CITY PLAN COMMISSION**THURSDAY, OCTOBER 19, 2023****FILE NUMBER:** S223-259**SENIOR PLANNER:** Sharmila Shrestha**LOCATION:** Hillcrest Plaza Drive, south of Lyndon B Johnson Freeway**DATE FILED:** September 22, 2023**ZONING:** NO(A)**CITY COUNCIL DISTRICT:** 11**SIZE OF REQUEST:** 7.452-acres**APPLICANT/OWNER:** 6700 LBJ Fwy, LLC

REQUEST: An application to replat a 7.452-acre tract of land containing all of Lot 1 in City Block B/7447 to create 3 lots ranging in size from 1.825 acre to 3.382 acre on property located on Hillcrest Plaza Drive, south of Lyndon B Johnson Freeway.

STAFF RECOMMENDATION: The request complies with the requirements of the NO(A) Neighborhood Office District; therefore, staff recommends approval of the request subject to compliance with the following conditions:

PRELIMINARY PLAT

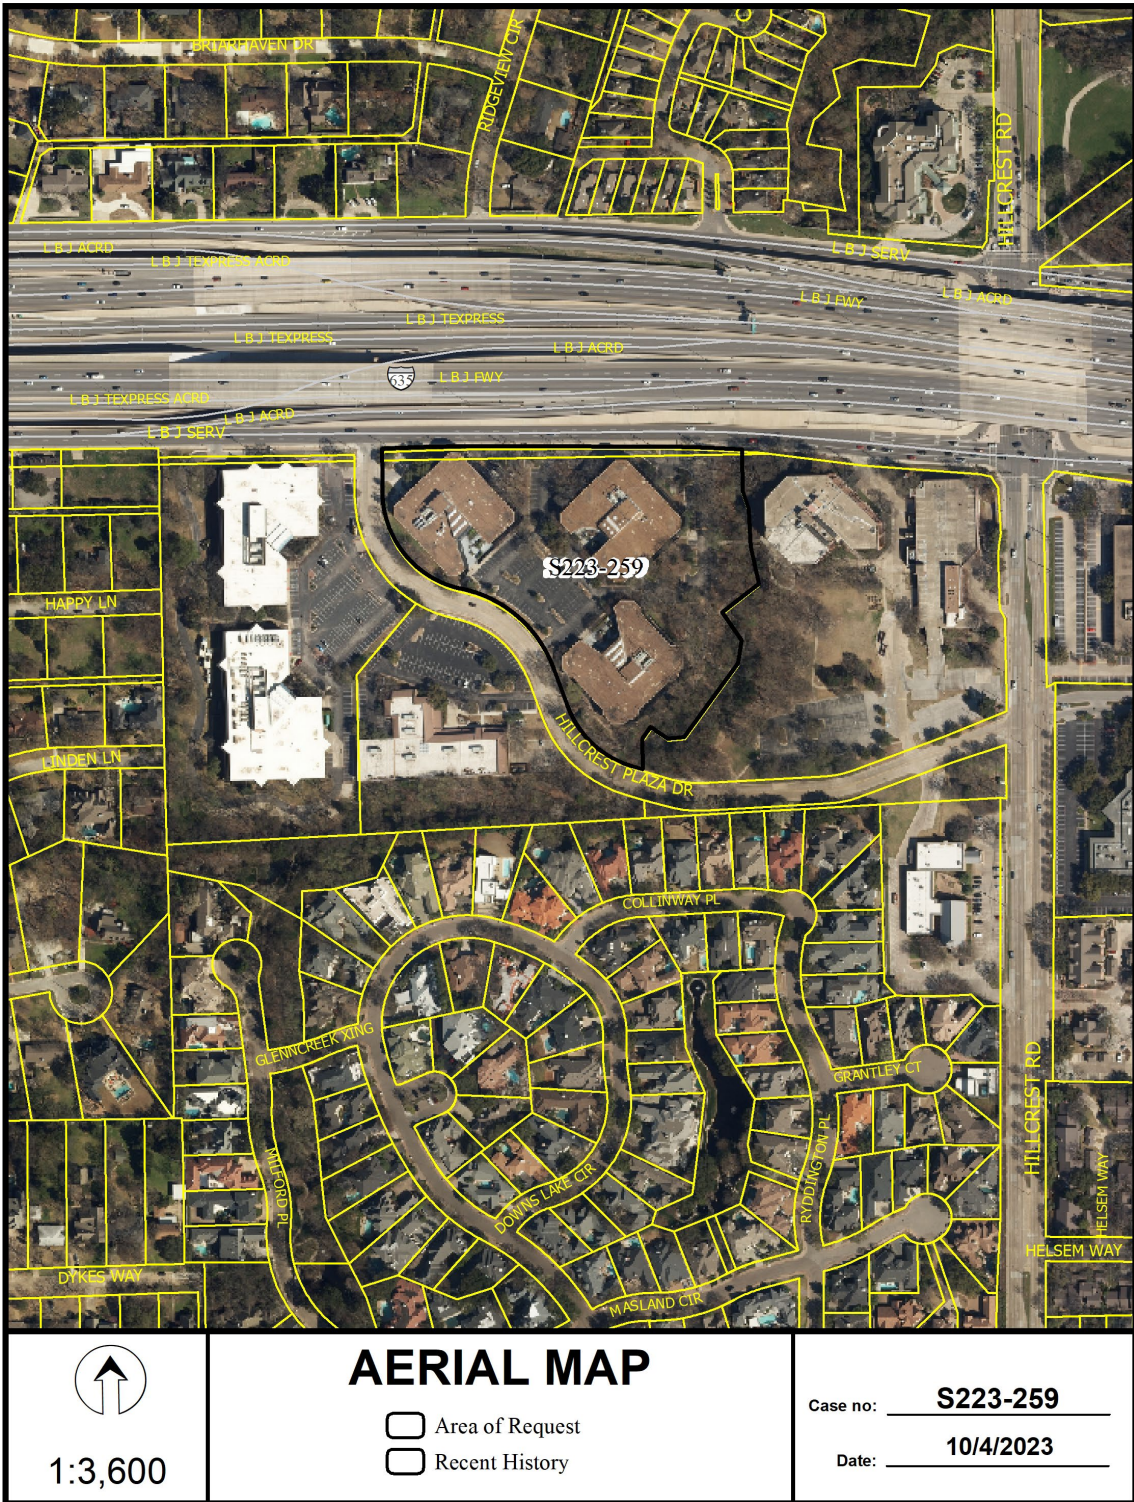
15. On the final plat, dedicate a minimum 5-foot by 5-foot corner clip (via fee simple or Street easement) at the intersection of Hillcrest Plaza and Lyndon B Johnson Freeway. Section 51A 8.602(d)(1).
16. A larger corner clip may be requested during engineering plan and traffic review to accommodate an adequate turning radius, or to maintain public/traffic appurtenances with the area of corner clip. Section 51A 8.602(d)(1), Section 51A-8.608(a)
17. TxDOT approval may be required for any driveway modifications or new access.

18. Prior to final plat, submit a completed final plat checklist and all supporting documents.
19. On the final plat, show recording information on all existing easements within 150 feet of the property.
20. On the final plat, show distances/width across all adjoining right-of-way.
21. On the final plat, show all additions or tracts of land within 150 feet of property with recording information.

23. On the final plat, change “Lyndon B. Johnson Freeway (I-635 Service Road)” to “Lyndon B. Johnson Freeway/ Interstate Highway No. 635”
24. On the final plat, identify the property as Lots 1A, 1B, and 1C in City Block B/7447.
